**STAFF REPORT - DESIGN REVIEW E
FINDINGS AND RECOMMENDATION**

HEARING DATE: April 3, 2019, 6:30 pm

REPORT DATE: March 27, 2019

FILE NUMBER: DRE/MP/TR 18-26000329 - WDC Sandy Mixed-Use Development

Minor Arterial:

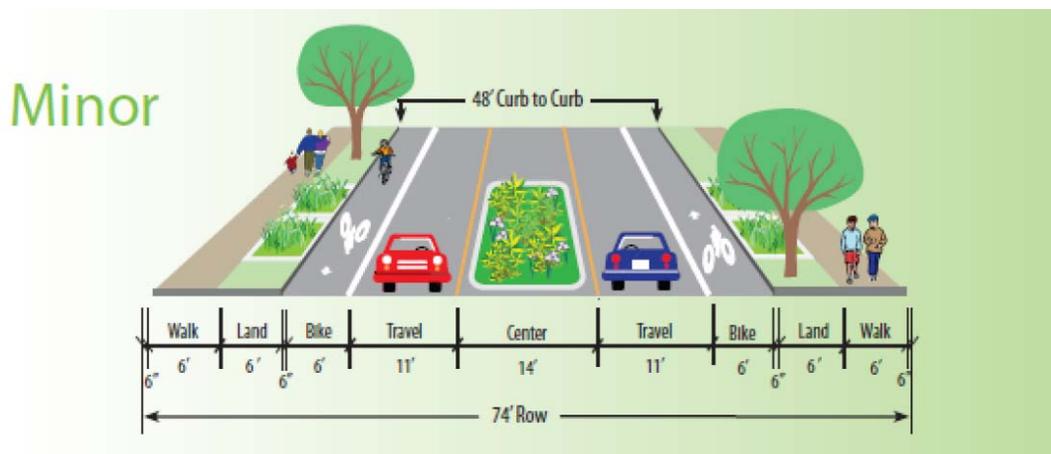
NE 185th Drive is classified as a Minor Arterial in the Transportation System Plan, requiring 74 feet of right of way or 37 feet of right of way to centerline. There is currently 30 feet of right of way measured to the center of the existing road and consists of: 24 feet of pavement, a 6-inch curb and a 6-foot curb-tight sidewalk. There have been previous right of way dedications from this site, so the center of the road as constructed does not align with the center of the right of way. The actual existing right of way along the site frontage is 35 feet, so a 2-foot dedication to provide for the standard 37 feet is required. The standard cross section for a Minor Arterial per GCDCA 5.501 is as follows.

Major Arterial

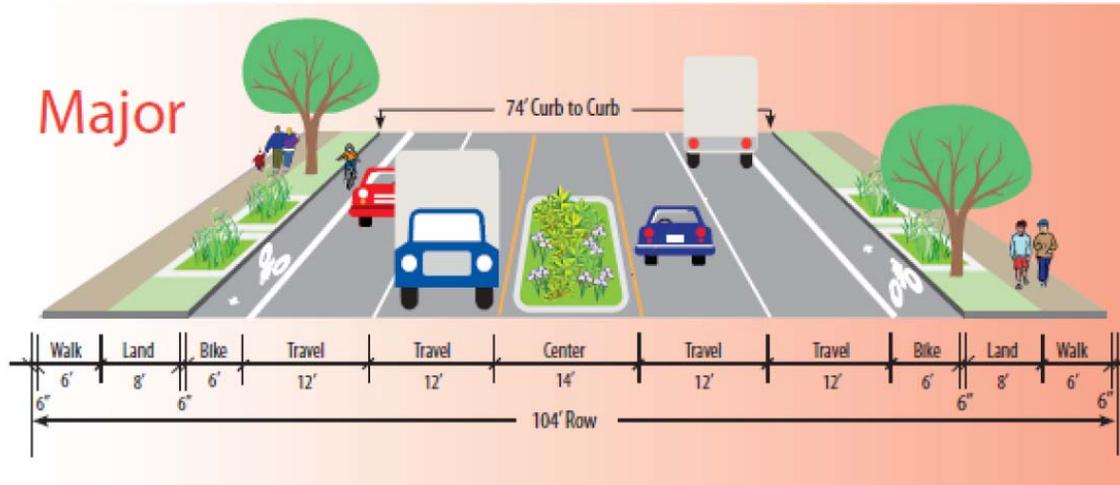
NE Sandy Boulevard is classified as a Major Arterial in the Transportation System Plan, requiring 52 feet of right of way to roadway centerline. There is currently 45 feet of right of way to centerline, consisting of roughly 24 feet of pavement and 21 feet of dirt. A 7-foot dedication is required along the project frontage to provide the standard 52 feet of right of way to centerline. The standard cross section for a Major Arterial per GCDCA A5.501 is as follows.

A corner dedication is required for the street intersection based on the long chord of the curb return radius of the lower classification street at the intersection. See PWS 6.02.11 for the curb return radii for each street classification and the City’s definition of the long chord.
